PLANNING, ZONING, & BUILDING DEPARTMENT
PZ&B Staff Combination Memorandum: Architectural Commission and Town Council

SUBJECT: ZON-23-021 (ARC-23-015) 320 CHILEAN AVE (COMBO)

MEETING: JULY 26, 2023 ARCOM
AUGUST 09, 2023 TC

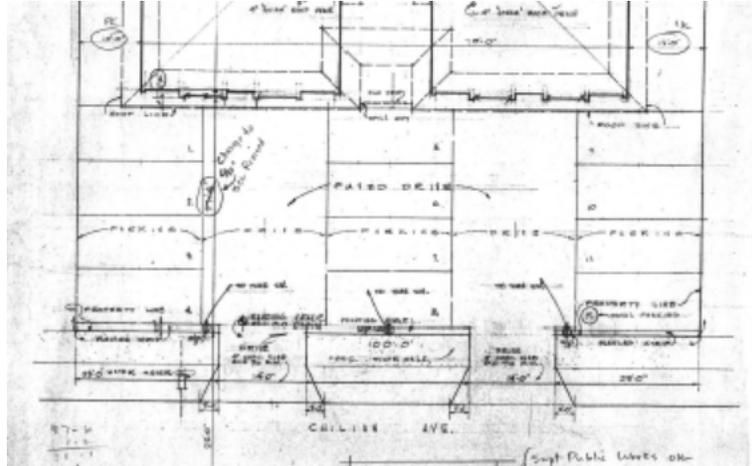
As it pertains to **Variances 1-3**, the applicant is proposing a new 8' x 20' pool in the east side yard of the building that encroaches into the required setback. As designed, the pool is located 2'-8" closer to the side property line than permitted (**Variance 1**). Additionally, the applicant has placed all the mechanical equipment within the south side yard of the building. This location exceeds the 25' maximum distance separation for pool equipment when the equipment is located within a building setback (**Variance 2**)—as proposed, the configuration is nearly 60' from the water's edge. See variance graphic below.

In addition to the pool pump and filtration system, there is also a proposed pool heater, which has a more restrictive side setback of 10'-0", rather than 5'-0" setback required other pool equipments (**Variance 3**). Staff maintains that the applicant should continue to explore ways to eliminate all of the variance requests for the installation of an amenity feature, as the reduced setback may negatively impact the neighboring duplex property.

1964 Paving Configuration

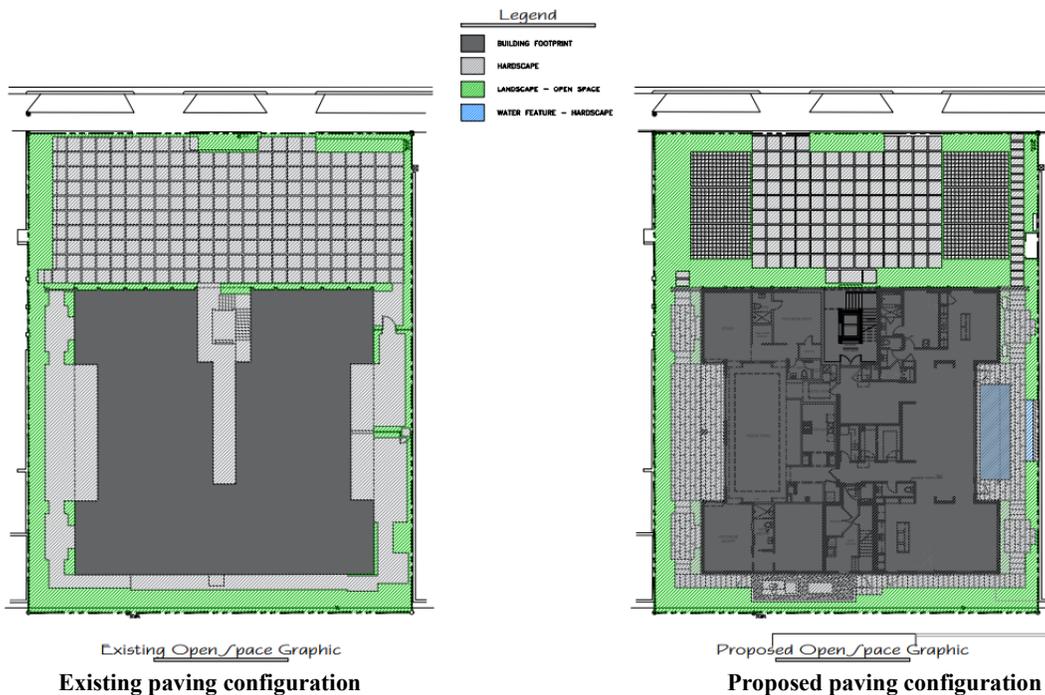
court area. The entire front area is configured as a large, paved car park area. The original 1964 design had an even greater area dedicated to car parking. See graphic below.

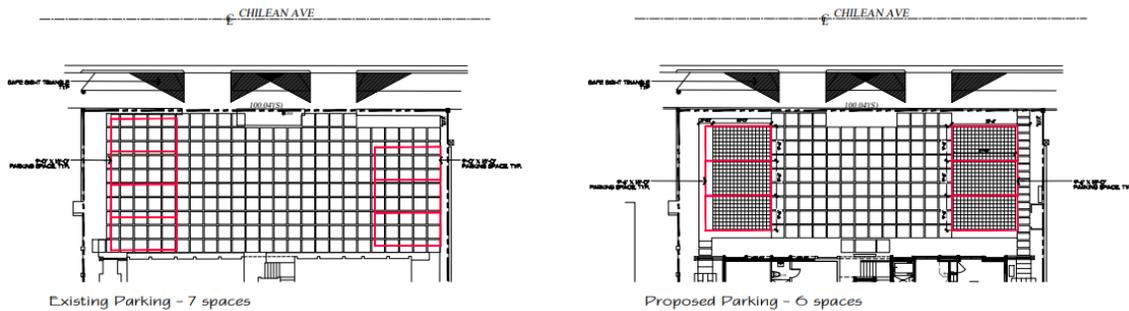
The application proposes to reconfigure the parking area and reduce the overall paving. The redesigned parkway area will be consolidated and reduced in area, resulting in an increase of the overall Landscape Open Space by 2.8%, or 364 SF.

Additionally, the redesign improves the amount of Front Yard Landscape Open Space by 2.5%, or 341 SF. Although the reduction of hardscape is an improvement to existing conditions, due to the extent of the improvements, the non-conforming Landscape Open Space (**Variance 4**) and Front Yard Landscape Open Space (**Variance 5**) must be reestablished. However, it must be noted that

the applicant seeks to install artificial turf within the joints of the paved parking area, likely for the durability of the material as opposed to designing with natural grass strips.
